TRANSMISSION—4R70W—NO FORWARD OR DELAYED ENGAGEMENT	Article No. 01-11-7

FORD: 2001 ECONOLINE, EXPEDITION, F-150

AUTHORIZED MODIFICATIONS

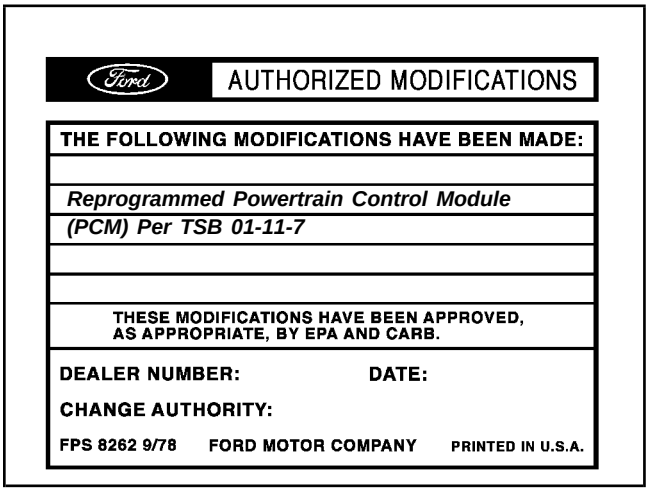
Obtain an Authorized Modifications Decal (STAT 5941-2 - obtainable through the PDC) and list the date, dealer number, and summary of modifications performed. Select a prominent place adjacent to the Vehicle Emission Control Information Decal suitable for installing the Authorized Modifications Decal. Clean the area, install the decal, and cover it with a clear plastic decal shield.

THE FOLLOWING MODIFICATIONS HAVE BEEN MADE:

Reprogrammed Powertrain Control Module (PCM) Per TSB 01-11-7
